## ADDENDUM NO. 04

<b>PROJECT:</b>	<b>Auburn Park Full Build-Out Montgomery County, VA Parks and Recreation</b>
<b>GNI Job No.:</b>	<b>2893.00</b>
<b>DATE:</b>	<b>Friday, March 15, 2024</b>

**FLOOR PLAN - RESTROOM BUILDING**  
1/4" = 1'-0"

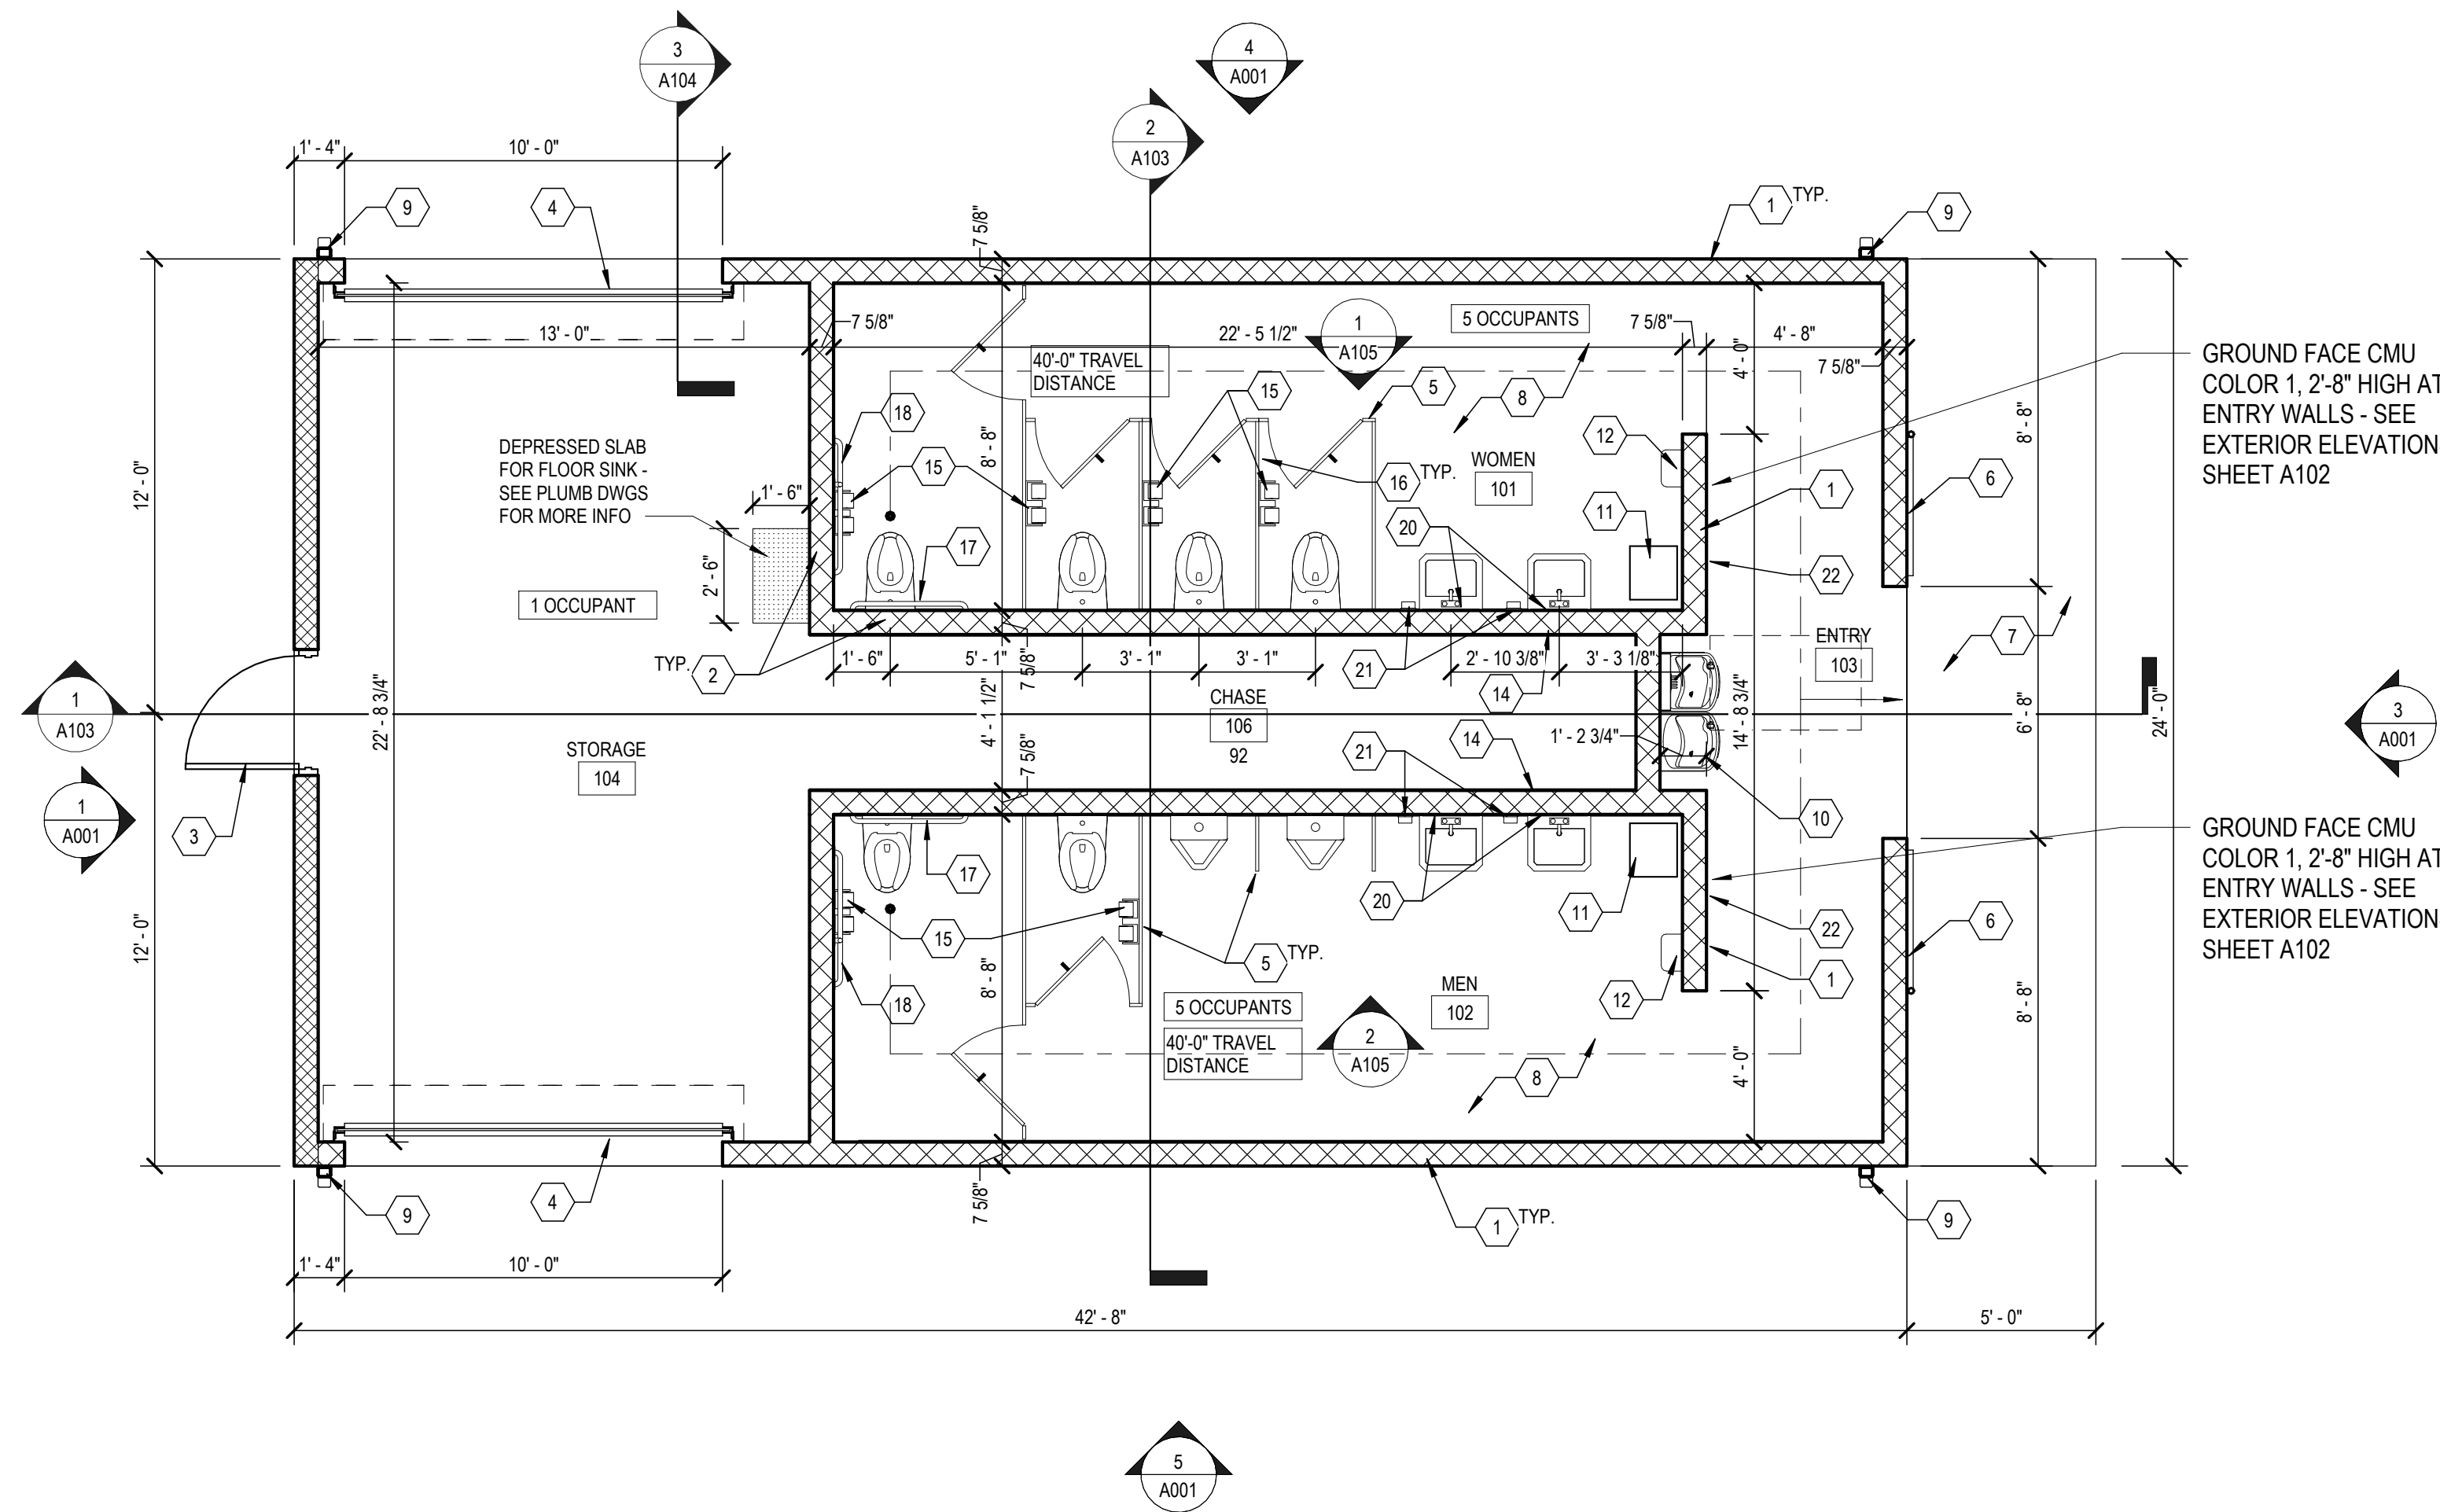
**DELETE** GENERAL FINISH NOTE #11 which reads as follows: “EXTERIOR WOOD TRIM AND FASCIA SHALL BE ALUMINUM WRAPPED, DARK GREY.” as shown in attached revised Sheet A101 with revision date 3-14-24.

**ADD** new GENERAL FINISH NOTE #13 which reads as follows:  
“EXTERIOR WOOD TRIM, ALUMINUM WRAPPED TO BE DARK GREY.” as shown in attached revised Sheet A101 with revision date 3-14-24.

**REVISE** KEY NOTE #9 to read as follows:  
“ALUMINUM DOWNSPOUT” as shown in attached revised Sheet A101 with revision date 3-14-24.

**REVISE** KEY NOTE #10 to read as follows:  
“WATER FOUNTAIN W/ BOTTLE FILLER (OASIS PG8SBFSL MODEL OR APPROVED EQUAL)” as shown in attached revised Sheet A101 with revision date 3-14-24.
